REMARKS

The above amendments and these remarks are responsive to the Office action mailed on February 15, 2000. Claims 1, 3-9, 11, 12, 15-19, 21-25, 32, 36 and 37 have been amended. Claims 2, 33-35 and 38-40 have been canceled. Claims 41-47 have been added. Claims 1, 3-32, 36 and 40-47 are now pending in this application. Reconsideration on the basis of the above amendments and remarks below is kindly requested.

Application No. 09/277,918

FIG. 11

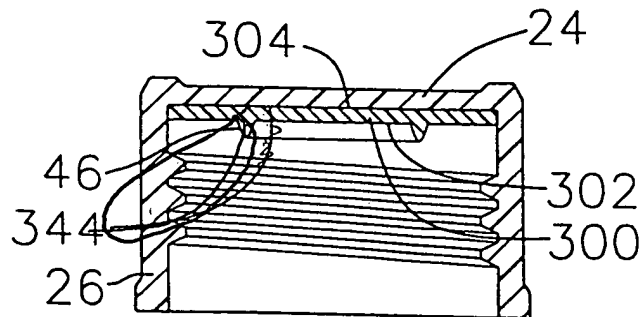
The Examiner objected to the drawings under 37 CFR 1.83(a). An amendment to the drawings is filed concurrently herewith under separate cover for approval and addresses the Examiner's objections

to the drawings. Specifically, FIGS. 13 and 14 have been added and FIGS. 10, 11 and 12 have been amended. FIG. 13 discloses a combination of a bottle neck, cap and disk having a circular ridge and a slot formed there across as claimed by claim 27. Claim 30 is directed to a cap, liner, disk and bottle neck combination where the disk has a circular ridge and a slot formed across the ridge. The liner has a hole through its thickness and is sandwiched between the ridge and the rim of the bottle neck. A disk having a ridge and a slot there through is disclosed in FIGS. 12 and 13. A liner having a hole through its thickness is disclosed in FIG. 7. As such, the subject matter of claim 30 is already disclosed in the drawings pending in this application. FIG. 14 discloses the combination of bottle neck, cap and disk having a plurality of grooves extending outwardly beyond the rim of the bottle neck as claimed in claim 32 as now pending in this application. FIG. 10 has been amended to correct the lead line from reference numeral 344. FIG. 11 has been amended to include a reference numeral 344 and a corresponding lead line. FIG. 12 has been amended to include reference numerals 48 and 344 and their corresponding lead lines.
